May 12, 2008

Re: Modification to Former Plainwell Impoundment Area Time-Critical Removal Action Design Report to Require Changes to the Bank Soil PCB Concentration Confirmation Monitoring and Inclusion of Area 11B in the Removal Action

The purpose of this letter is to confirm that, pursuant to Paragraph 74 of the Allied Paper/Portage Creek/Kalamazoo River Superfund Site Administrative Settlement Agreement and Order on Consent for Removal Action (Docket No. V-W-07-863), U.S. EPA requires modifications to the Former Plainwell Impoundment Area Time-Critical Removal Action (TCRA) Design Report, dated February 2007 (Work Plan). The modifications include changes in the Bank Soil PCB Concentration Confirmation Monitoring presented in Section 5.4.3 of the Work Plan, and the inclusion of Area 11B in the TCRA.

R-1.2

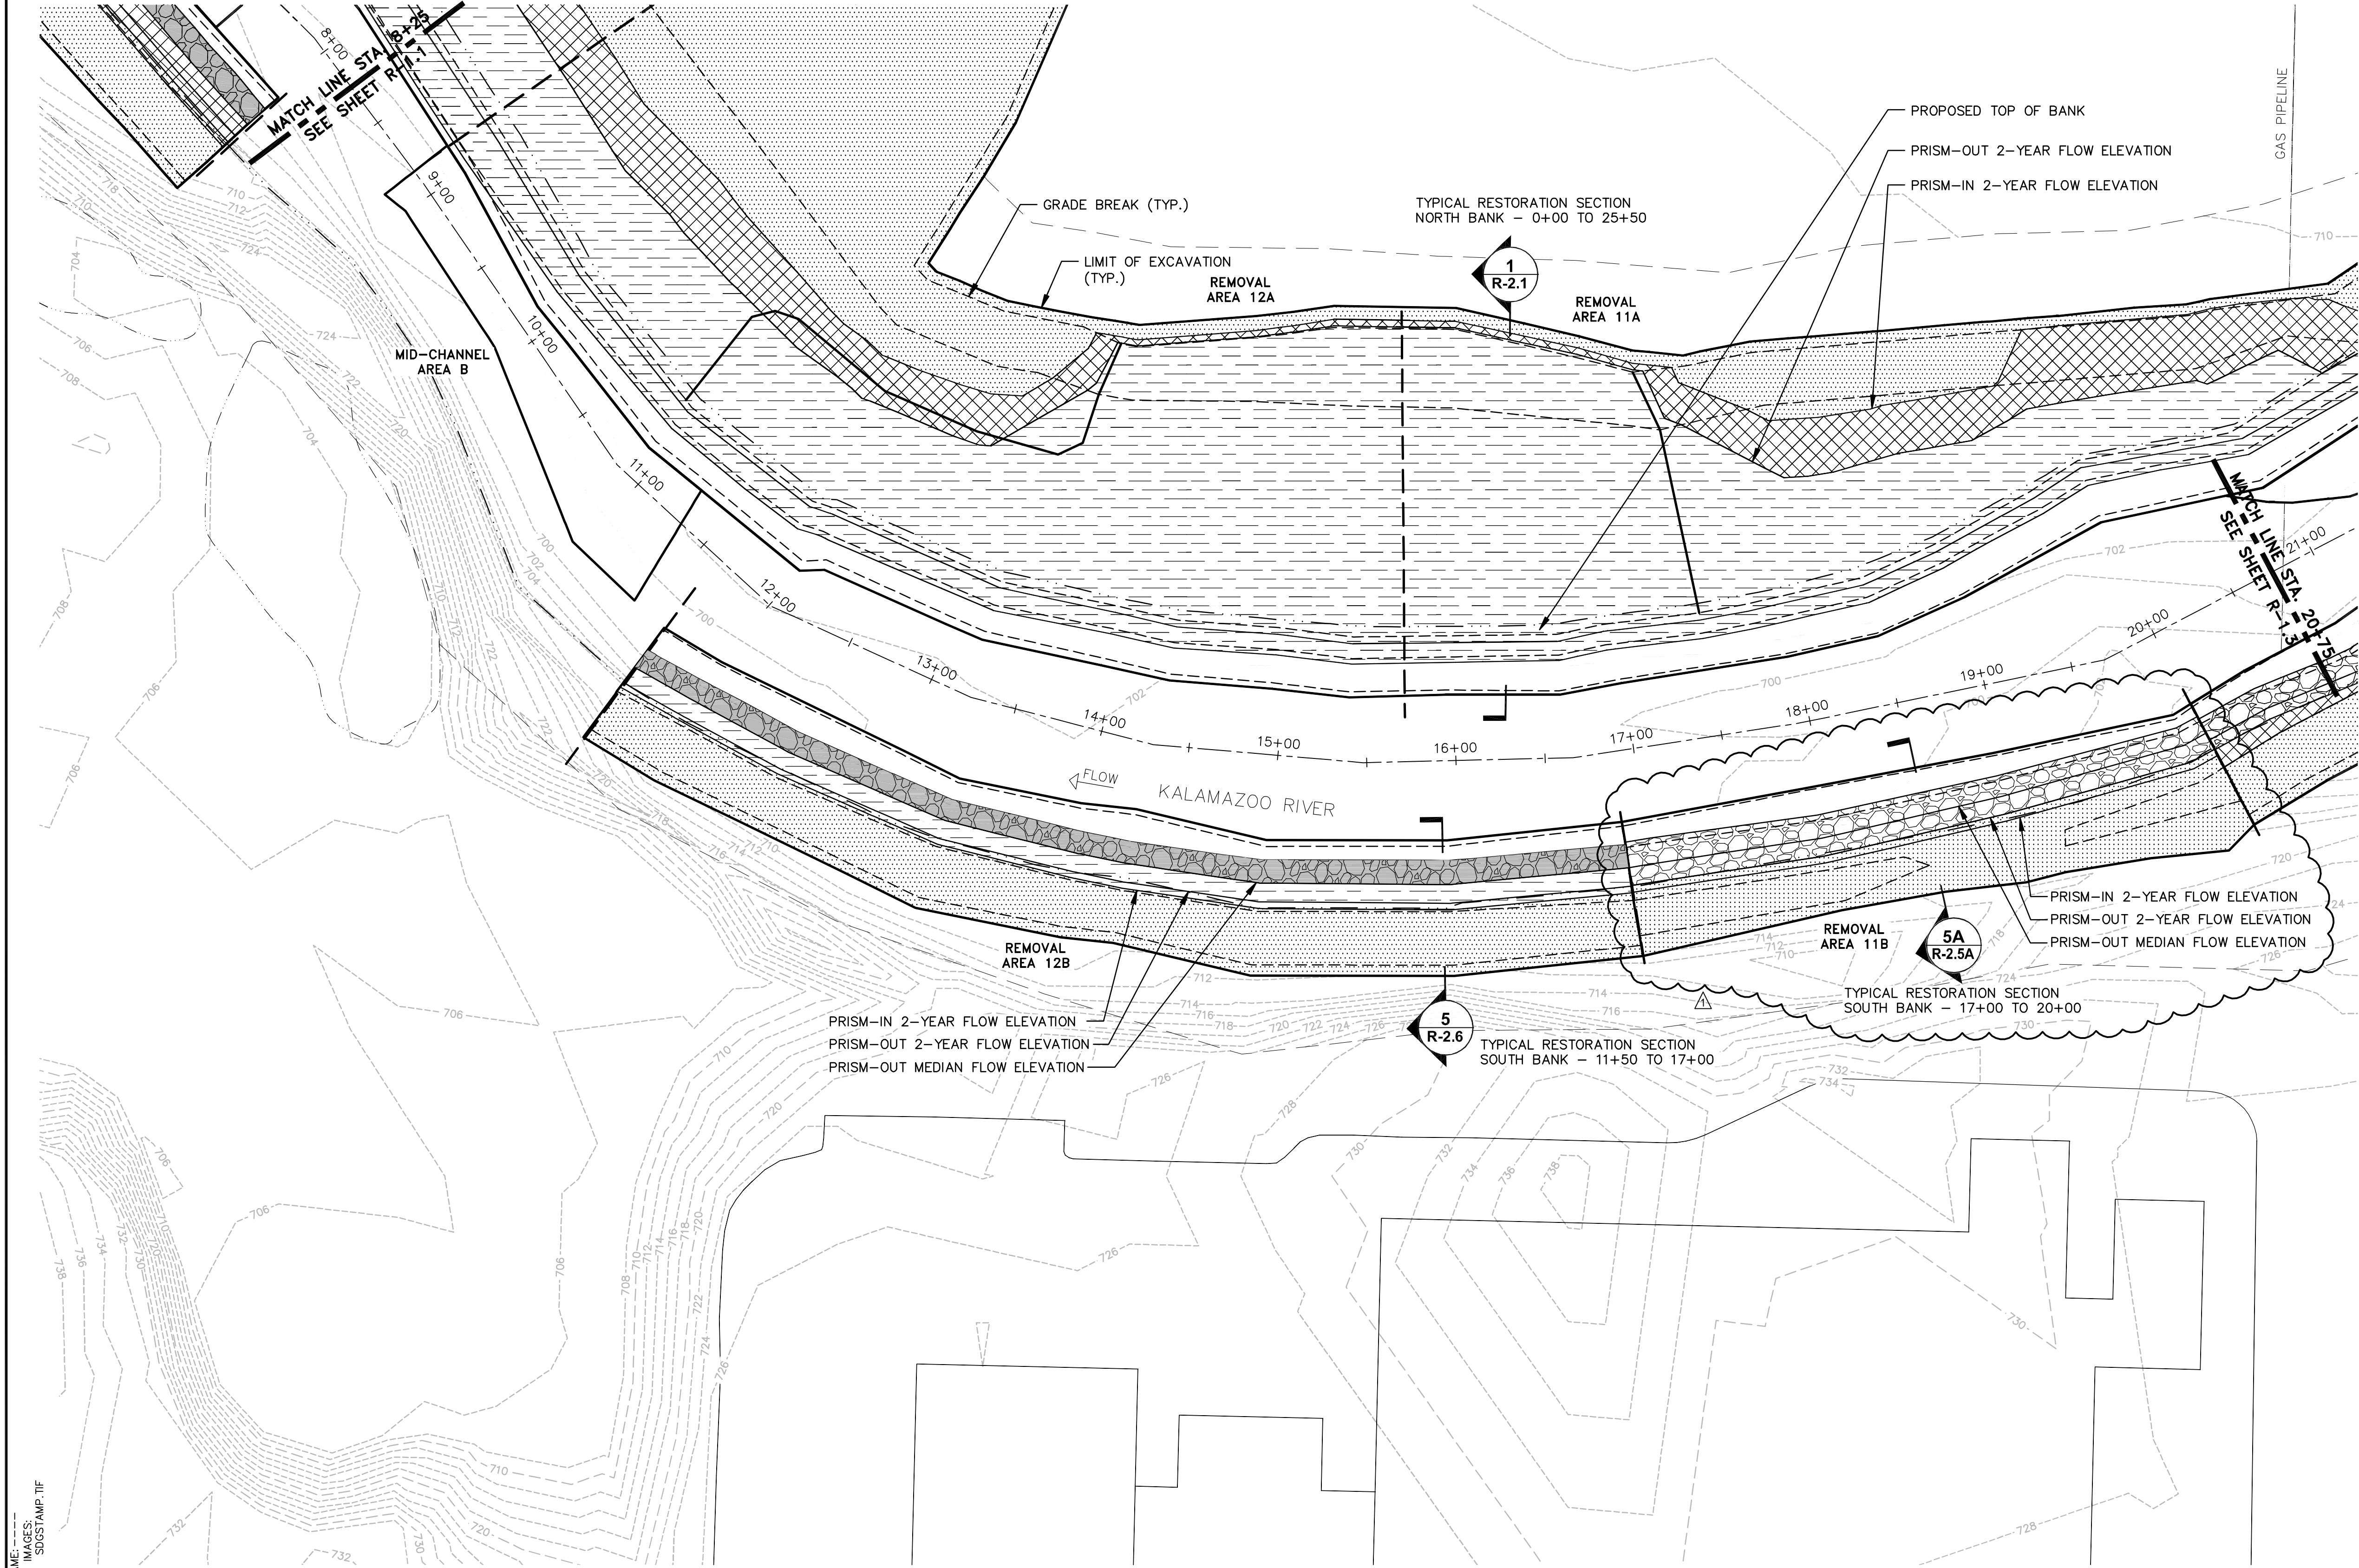
In addition, U.S. EPA and MDEQ have recently inspected Area 11B with ARCADIS representative E.J. Suardini and determined that access into this area is possible to conduct removal activities. This area was previously thought to be inaccessible and was not included in the Work Plan. Therefore, U.S. EPA requires Respondents to modify the Work Plan to incorporate Area 11B into the TCRA. U.S. EPA requests that within 20 days of receipt of this letter, the KRSG submit a proposal for conducting the removal work in Area 11B.

No.	Date	Revisions	Init
1	06/04/08	ADDED REMOVAL AREA 11B
